Subject: Grand Gulf Nuclear Station  
Unit 1  
Docket No. 50-416  
License No. NPF-29  
Response to NRC Request for Additional Information  
Regarding Cycle 12 Reload Proposed Amendment,  
LDC-2000-076

GNRO-2001/00025

Response to Request for Additional Information

Figure 1.2 : EOC Radial Power Histogram

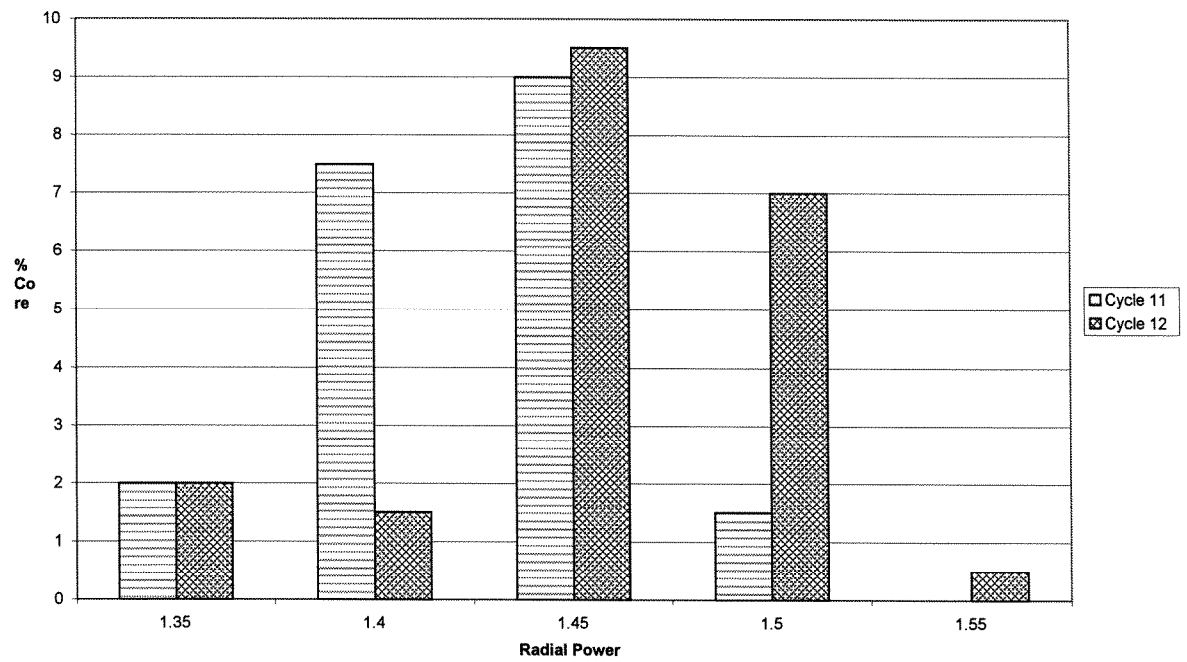
**Provide the fuel types and numbers of assemblies used in Grand Gulf Nuclear Station, Unit 1 (GGNS), Cycle 12 operation and identify if they are fresh or irradiated fuel (once or twice burned, etc.) Also, provide the fuel loading pattern for Cycle 12 operation, identify its difference from Cycle 11, and the impact on the SLMCPR calculation.**

The full core loading map is provided in Figure 1.1. While we do not expect this information to change, any final core design changes will be evaluated to confirm that the proposed Technical Specification changes remain valid.

The cycle 12 loading plan is very similar to the cycle 11 core loading. Both cycles use a conventional core loading in which fresh and irradiated fuel bundles are distributed in a checker board configuration throughout the interior region of the core with more depleted fuel loaded on the core periphery. The specific loading pattern is selected to meet fuel design limits while maximizing cycle energy. The potential fuel loading impact on the MCPR safety limit is illustrated by Figure 1.2 which shows the high power portion of the end-of-cycle power histograms. The Cycle 12 histogram is shifted to slightly higher powers due to the improved thermal performance of the Atrium 10 fuel but the shapes are very similar. Since the safety limit is more sensitive to the shape of the histogram, this indicates the core loading changes have little impact on the difference between the Cycle 11 and 12 MCPR safety limits. The difference is attributed primarily to the differences in methodology between the two analyses. With additional reload batches of Atrium 10 fuel, the radial power distribution is projected to flatten so the proposed safety limit includes margin to accommodate the anticipated impact of these changes.
